PROJECT: **CITY OF MOLALLA WATER SYSTEM INTAKE IMPROVEMENTS**

SHEET TITLE: **VICINITY MAP AND SITE PLAN FOR PROPOSED INTAKE IMPROVEMENTS**

CITY OF MOLALLA, OREGON			
WATER SUPPLY IMPROVEMENTS DETAILS OF SAND TRAP			
SCALE As Noted	DATE July 21, 1953	J.O. 5321-243	
DRWG. BC	CLARK & GROFF ENGINEERS 3245 S. COMMERCIAL ST. SALEM, OREGON	SHEET	2
DSGN. LKC		NO. →	
CHKD. LKC		OF 2

CITY OF MOLALLA, OREGON		
WATER SUPPLY IMPROVEMENTS LAYOUT OF COLLECTION SYSTEM		
SCALE 1" = 20 ft.	DATE July 21, 1953	J.O. 5321-228
DRWG. B.C.	CLARK & GROFF ENGINEERS 3245 S. COMMERCIAL ST. SALEM, OREGON	SHEET
DSGN. LKC		NO. →
CHKD. LKC		OF 2

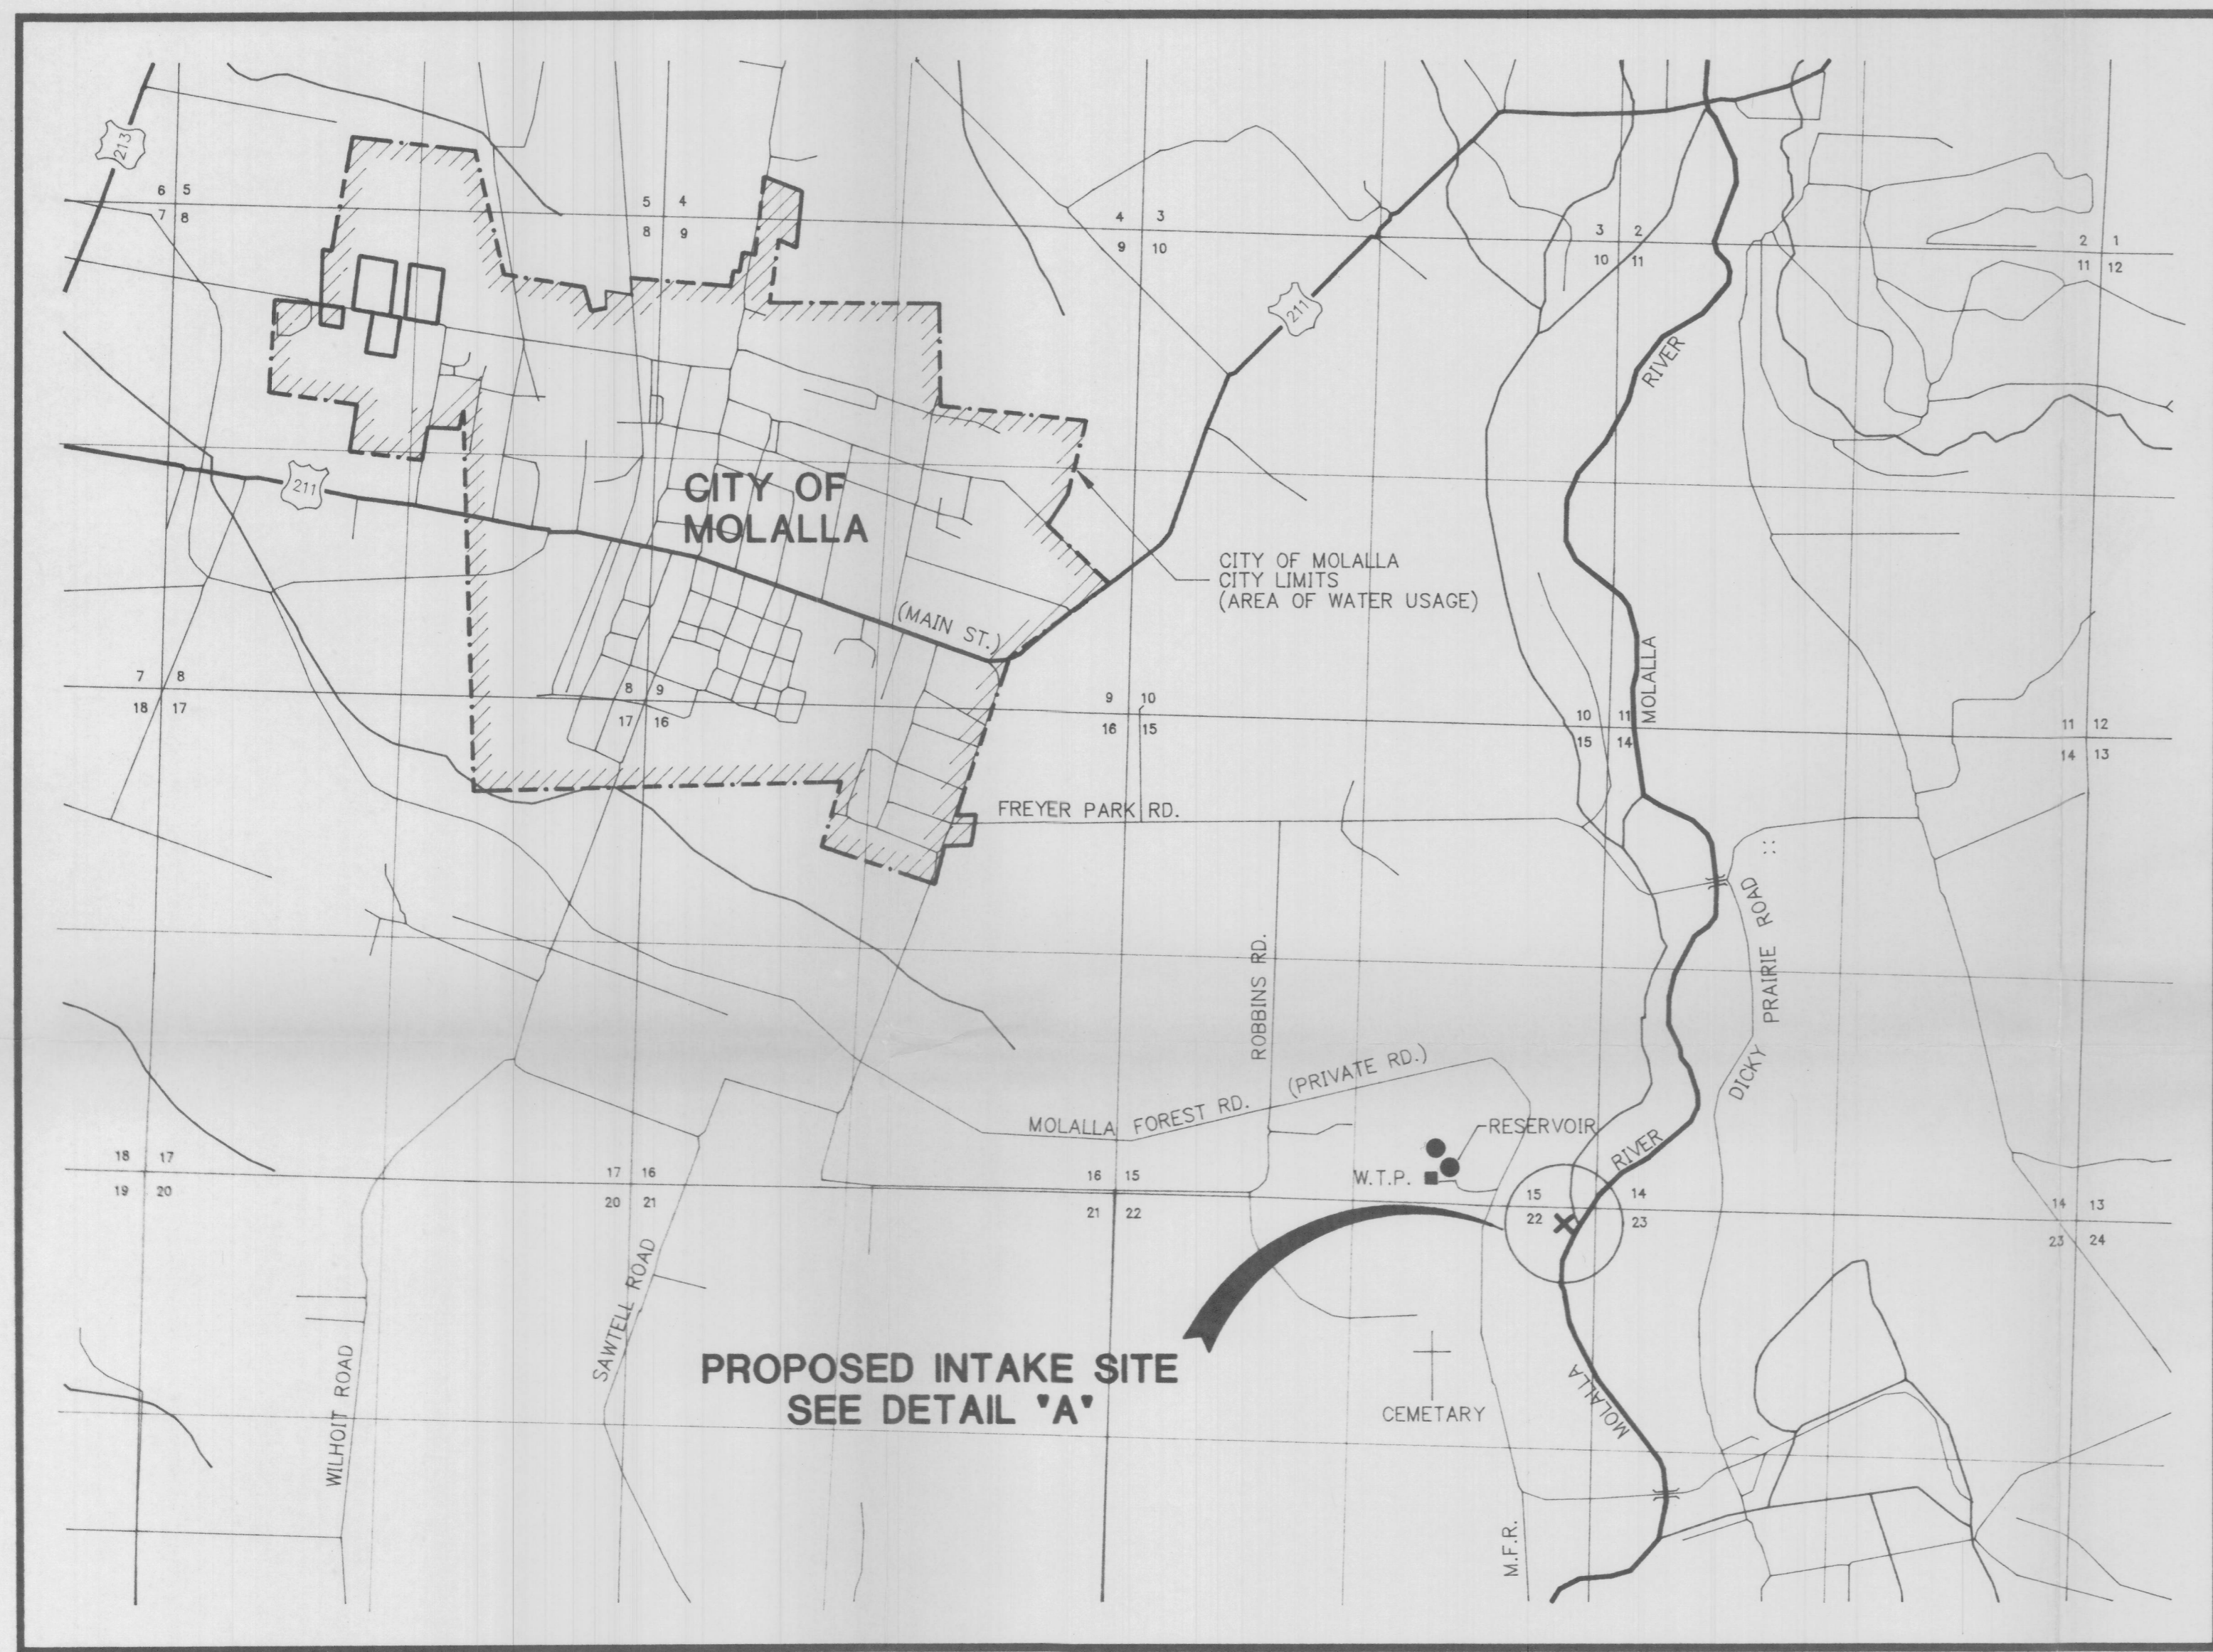
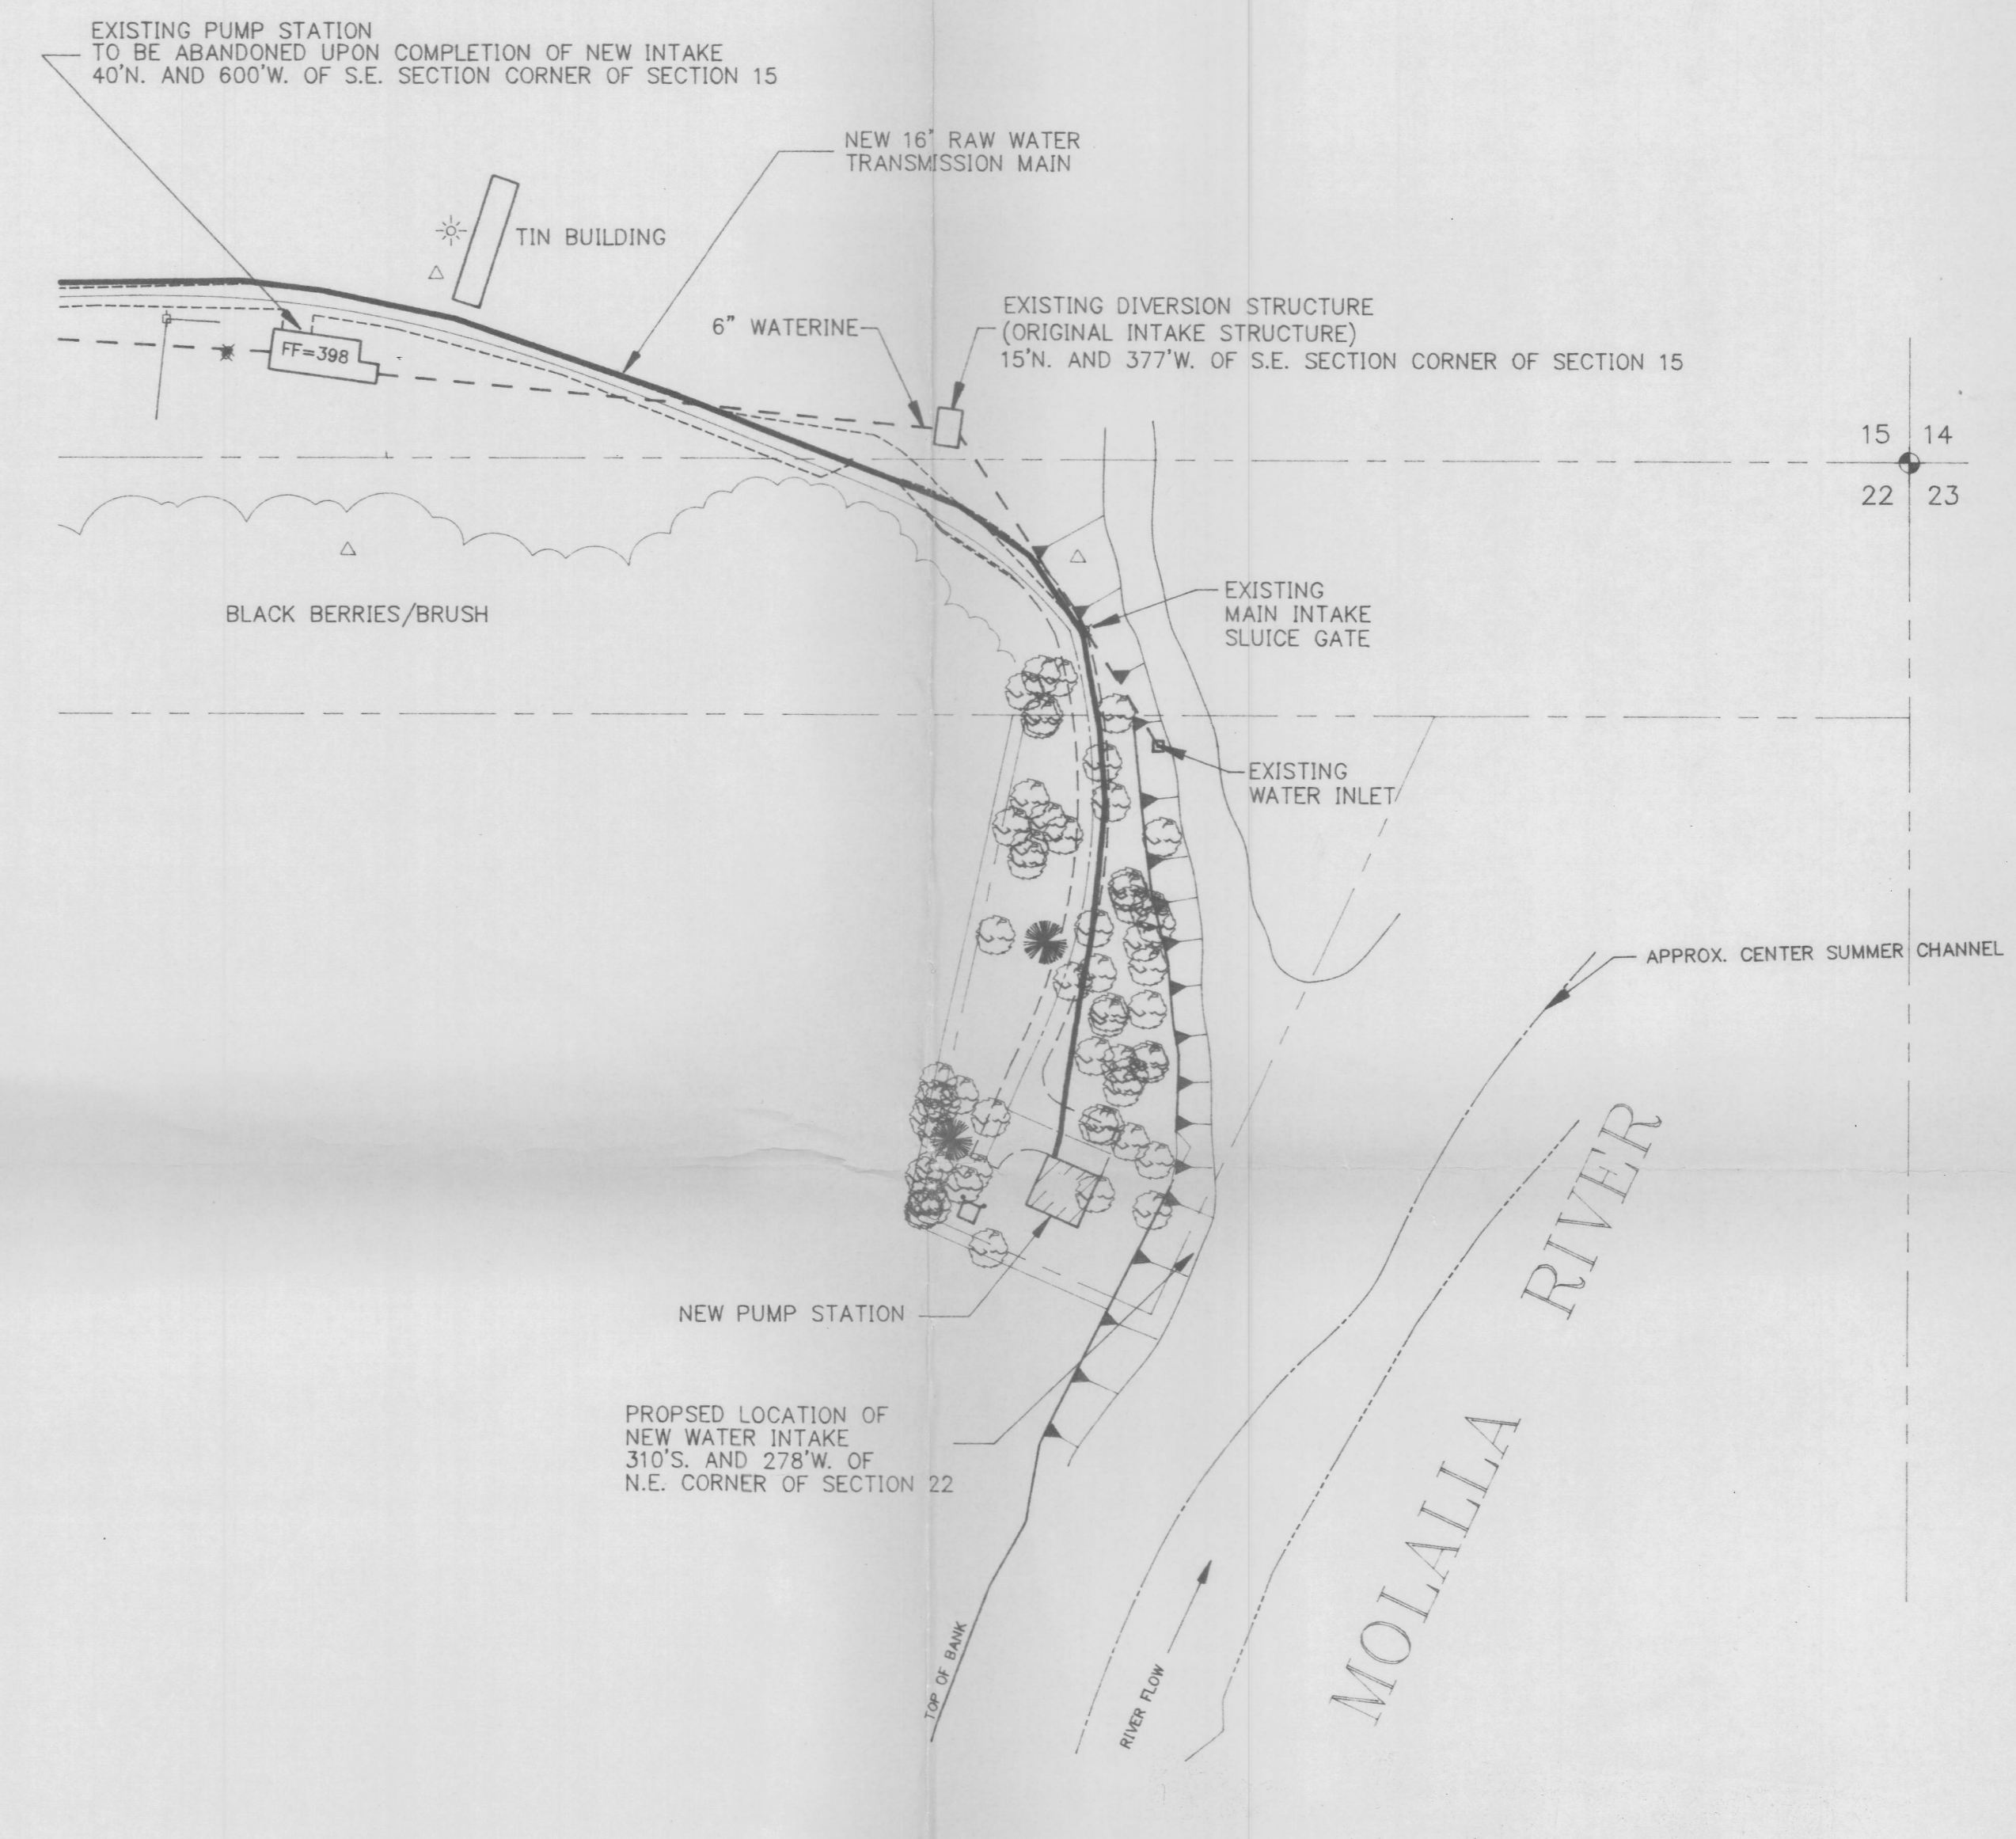
*City has a new pump plant. Will write letter requesting to make proof in new location*  
5/19/93  
*J. Duane Lee*
